Change Notice

FT Series

Changes to ITO Film for FT Series Analog Resistive Touch Screens

Cross Section View of Touch Screen	Before Change	After Change
	<p>Surface Hardness: 2H (JIS K 5600)</p>	<p>Surface Hardness: 3H (JIS K 5400)</p>

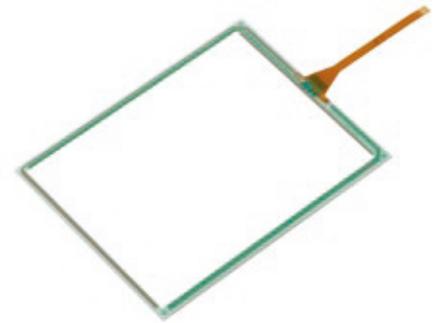
FT Series Touch Screens will be undergoing changes to the ITO film (top electrode). This revision will apply to the four-wire analog resistive touch screens, the four-wire analog resistive touch screens with FPC tails, and the five-wire analog resistive touch screens, both standard and custom models. The hardness of the film, previously 2H, will be changing to 3H. Details are highlighted on the following table.
